Common Response 6.1

Sacramento Water Allocation Model and Changes in Hydrology and Water Supply

Figure CR 6.1-1. Annual Total Supply from Putah Creek for Baseline, 55 w/WSAs and 55 Scenarios

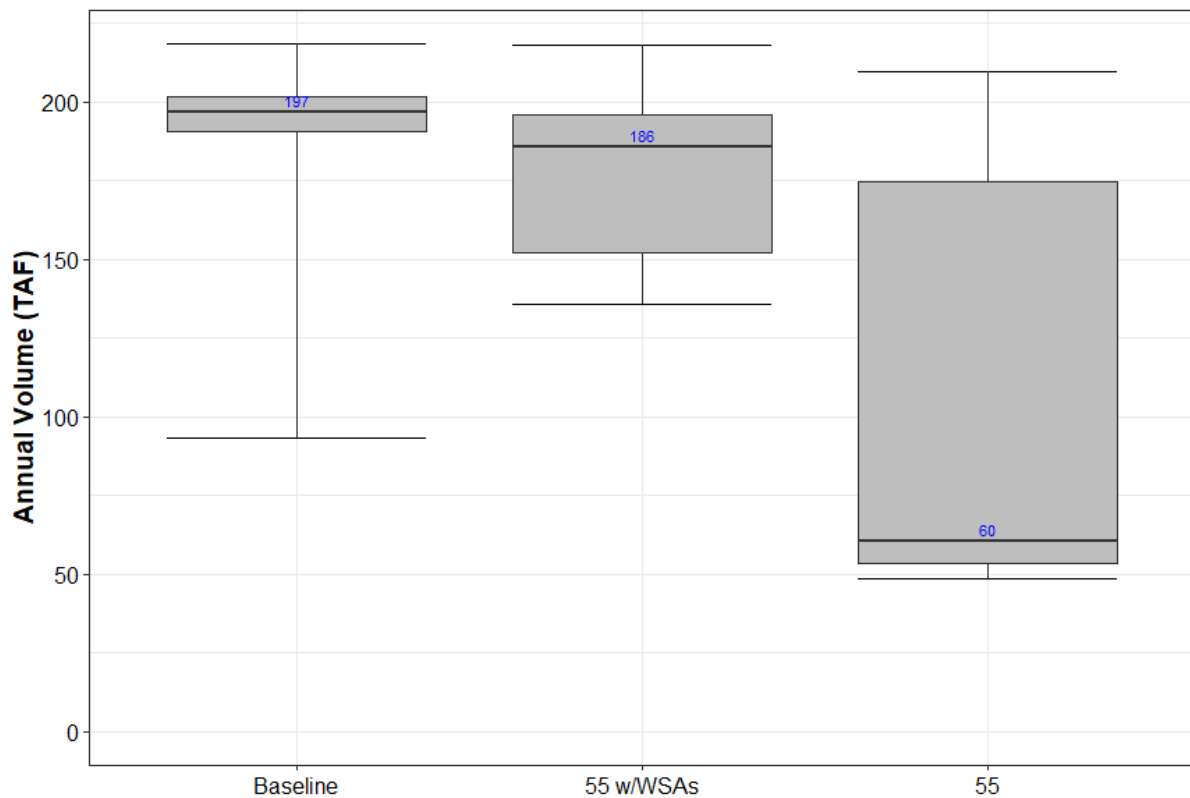
Suisun-Solano Water Authority (SSWA) asserts in comments that their independent evaluations of the modeling assumptions in Chapter 13, *Revised Proposed Plan Amendments*, demonstrated that the 55 w/WSAs scenario would result in zero water deliveries to SSWA in 10 percent of years under the low carryover storage requirement. SSWA did not provide any details on how their analysis was performed, however SacWAM results show much smaller reductions in water supply in the 55 w/WSAs scenario. Figure CR 6.1-1 shows that there are no years when the supply is reduced below 125 TAF per year under the 55 w/WSAs scenario and Table CR 6.1-1 shows that the average annual reduction for the 55 w/WSAs scenario is 20 TAF or 10 percent from baseline. The maximum reduction appears to occur most often in below normal water year types when the relaxation to the flow requirements may not have triggered. These reductions are dispersed throughout the time period, not all occurring in sequence and thus there are periods of recovery between periods of intermittent delivery reductions. Considering the lower magnitude in delivery reductions and the dispersed nature of the reductions, it is likely member agencies could work cooperatively together to reduce the impacts to any one city. There are also provisions in the revised proposed Plan amendments for development of curtailment exceptions for human health and safety needs to reduce impacts from extreme conditions.

Figure CR 6.1-4. Comparison of SacWAM Existing Conditions Simulated Storage and Historical Observed Storage for Camanche Reservoir. Source: SacWAM version 2025.08.28 and CDEC 2026.

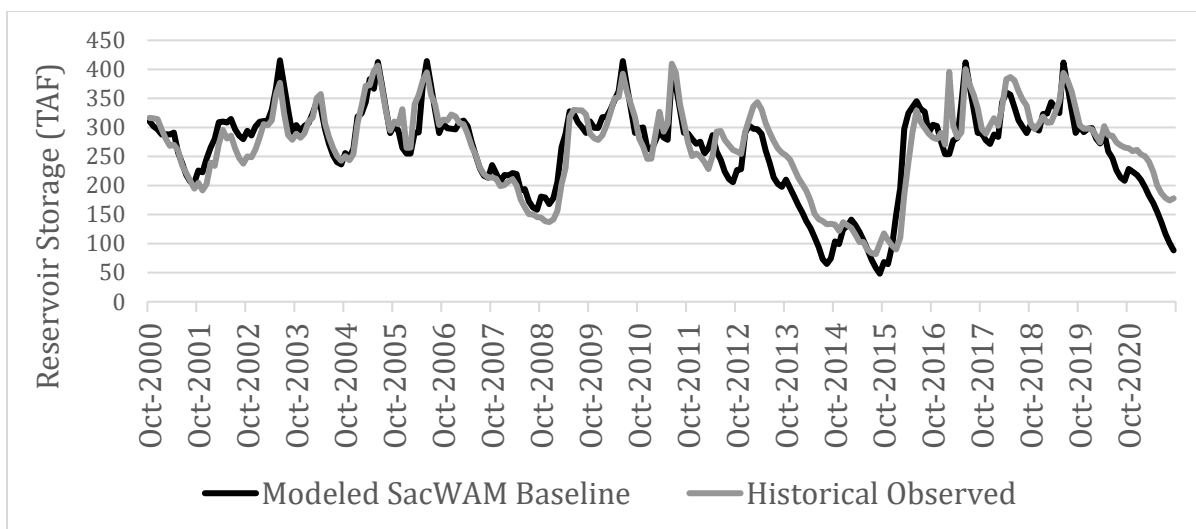
The Board received multiple comments by EBMUD contending that because SacWAM does not match their model, EBMUDSIM, SacWAM is flawed, and that the Staff Report should rely on EBMUDSIM instead. Comments asserting that inter-model comparisons show SacWAM poorly representing historical operations do not hold merit because such arguments assume that EBMUDSIM perfectly represents historical operations, yet EBMUD did not provide any comparisons of EBMUDSIM or SacWAM to historical observations to support this assertion. As referenced above, when SacWAM is compared with recent historical observations, its simulation results align well with historical reservoir storage, diversions and streamflows (see below for an example of recent historical storage and modeled baseline storage for Camanche Reservoir using SacWAM). The Nash-Sutcliffe model efficiency metric for the Camanche Reservoir storage shown in Figure CR 6.1-4 is 0.79 (out of a maximum value of 1.0), which indicates a very strong match between SacWAM results and observed historical data. Differences in model results between SacWAM and EBMUDSIM could be explained by differences in model assumptions (EBMUDSIM's assumptions were not provided) or inaccuracies in EBMUDSIM. Regardless, the fact that SacWAM results depicting existing conditions do not match EBMUDSIM results does not mean SacWAM is flawed or that it is an inappropriate tool to analyze the impacts of the update of the Bay-Delta Plan.

When the simulation results of existing conditions are compared with recent historical observations for reservoir storage and streamflow, the results confirm that SacWAM accurately represents the hydrology and diversions and is well-suited for an environmental analysis of a project of this scale. Perhaps more importantly, the model is capable of estimating the amount by which diversions could be reduced if a percent of unimpaired flow was required to be bypassed while maintaining sufficient reservoir storage for cold water habitat.
